V2500 Propulsion System - Nacelle **SERVICE BULLETIN**

NACELLE – HYDRAULIC SYSTEM – INTRODUCTION OF AN EXTERNAL DAMPENER FOR
EATON ENGINE DRIVEN PUMPS (EDP)

V2500 Series 29-0265

V2500-NAC-29-0265

v2500-nac-29-0265_01.iso

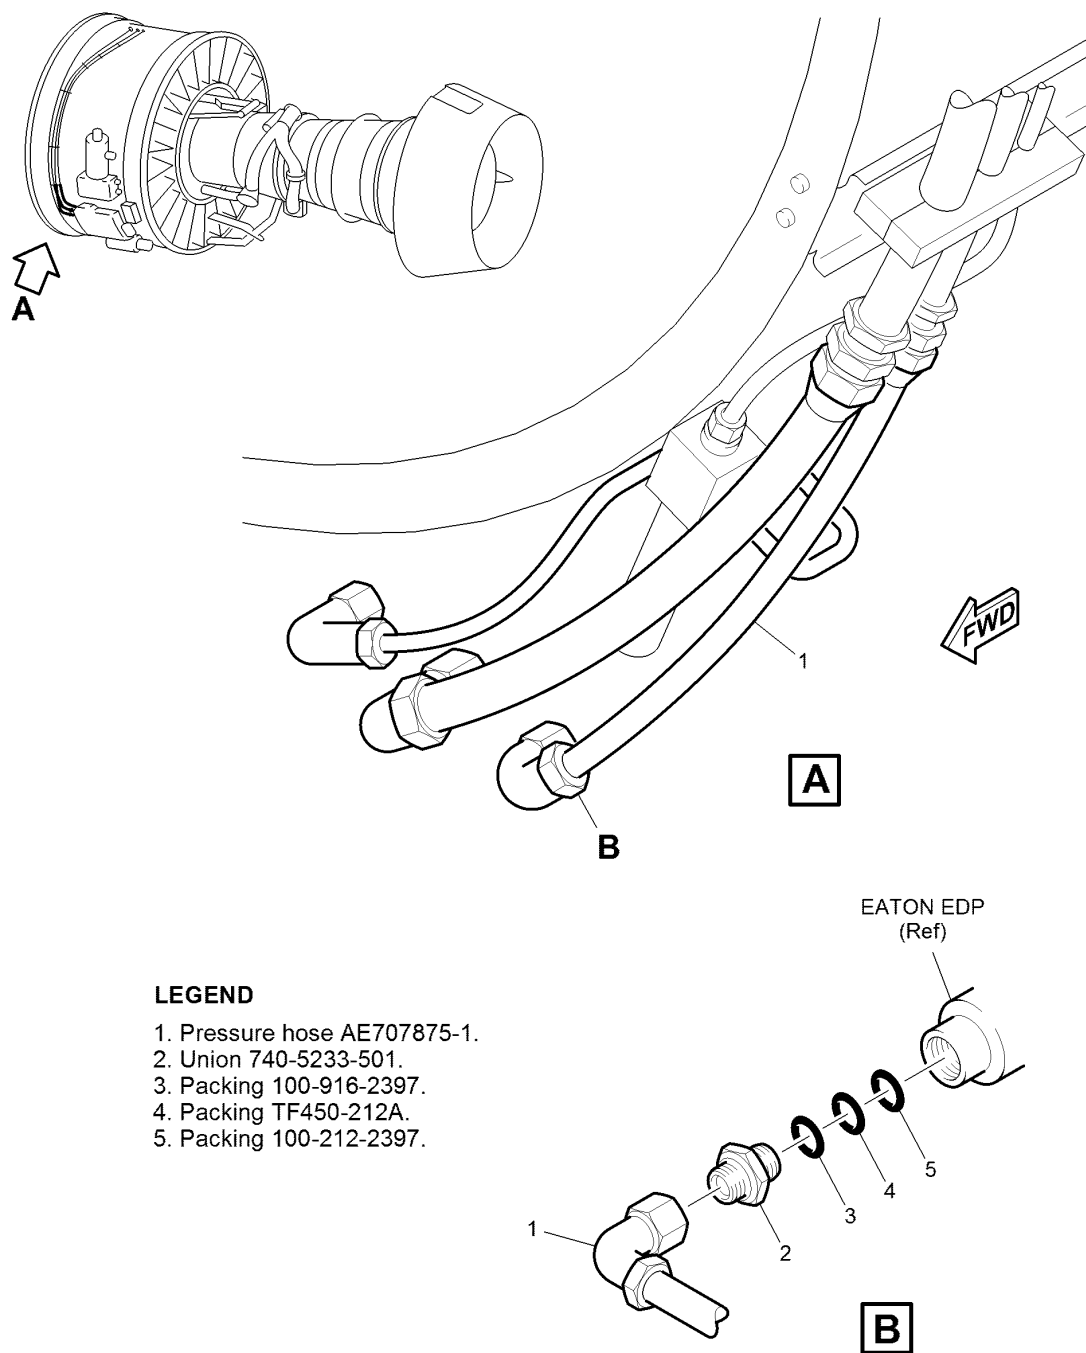
1. Removal of the union (2) from the Eaton EDP (ref). Refer to Figure 1.
 - A. Put a suitable container below the pressure hose (1) / union (2) connection to the Eaton EDP.

- B. Hold the union (2) with an applicable wrench and disconnect the pressure hose (1) from the union.
 - C. Let the hydraulic fluid flow into the container.

- D. With an applicable wrench, remove the union (2) and packing (3), (4) and (5) from the EDP (ref).
 - E. Discard the packing (3), (4) and (5).
 - F. Put a suitable protective cover on the end of the pressure hose (1) and the EDP (ref).

Figure 2
Installation of EDP Dampener.

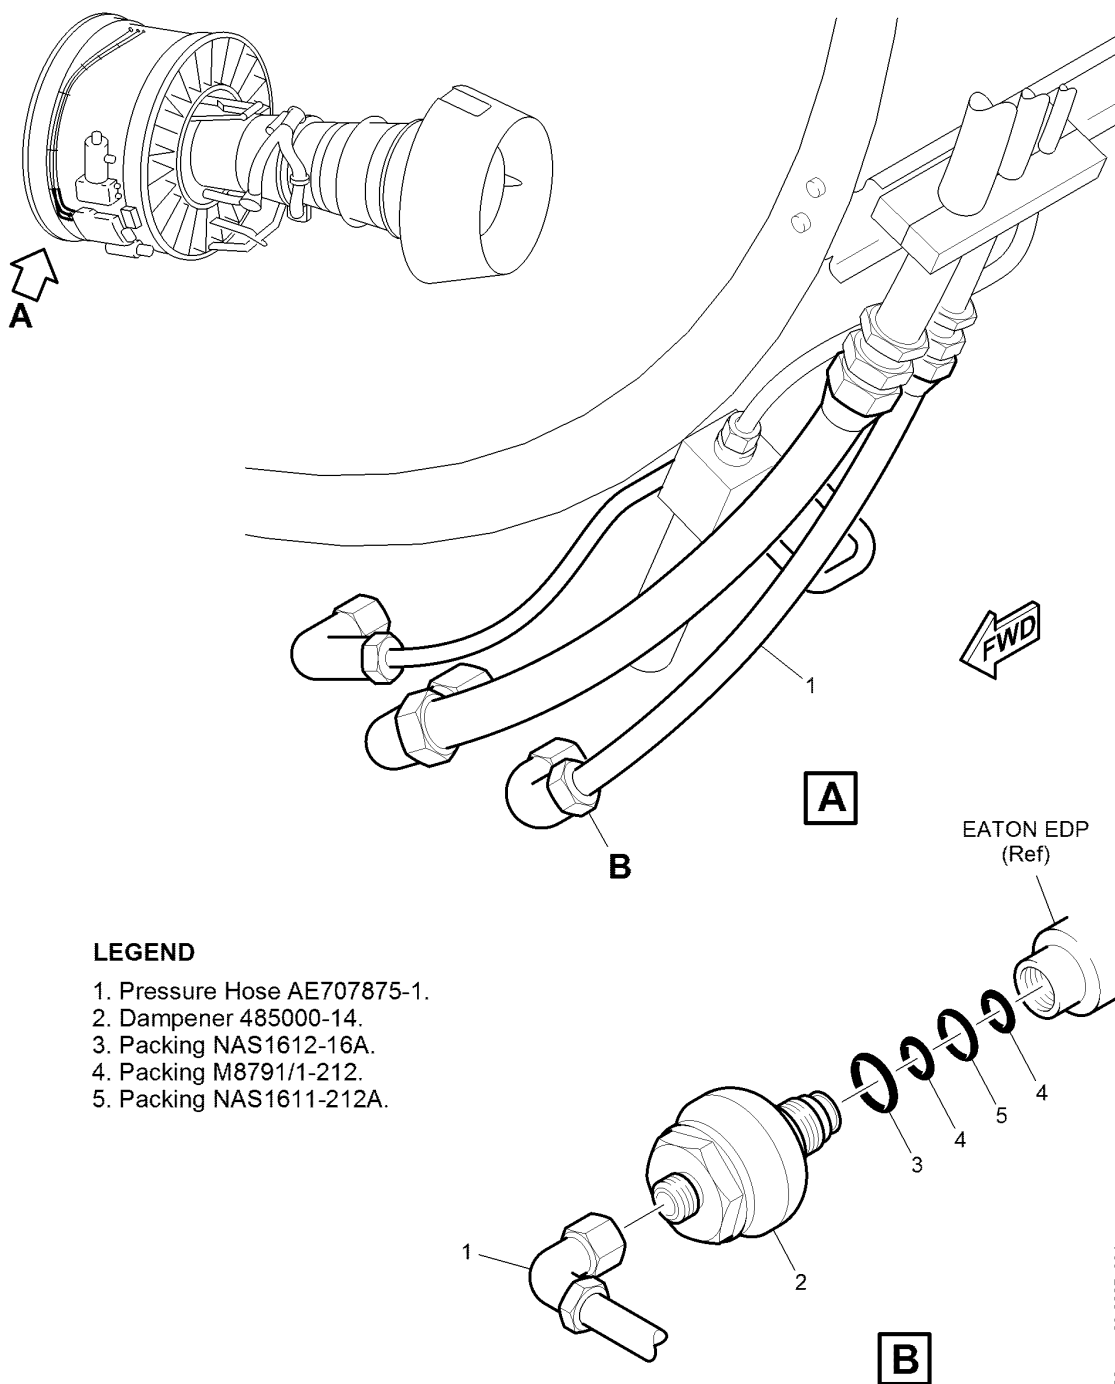
2. Installation of the new dampener (2) on the Eaton EDP (ref). Refer to Figure 2.
 - A. Remove the covers from the dampener (2), the pressure hose (1) and the EDP (ref).

- B. Lightly lubricate the threads and abutment faces of the dampener (2) and pressure hose (1) with the hydraulic fluid used in the aircraft hydraulic system.

- C. Lubricate the packing (3), (4) (2-off) and (5) (ref SPM Task 70-44-01-400-501) and install the new dampener (2) and packings (3), (4) (2-off) and (5) to the Eaton EDP.

- D. Torque the dampener (2) to 975 – 1060 lbf in. (110,2 – 119,8 Nm).

E. Connect the pressure hose (1) to the dampener (2).

F. Hold the dampener (2) with an applicable wrench and with a second wrench, torque the connector nut of the pressure hose (1) to 752 – 840 lbf in. (85,0 – 95,0 Nm).
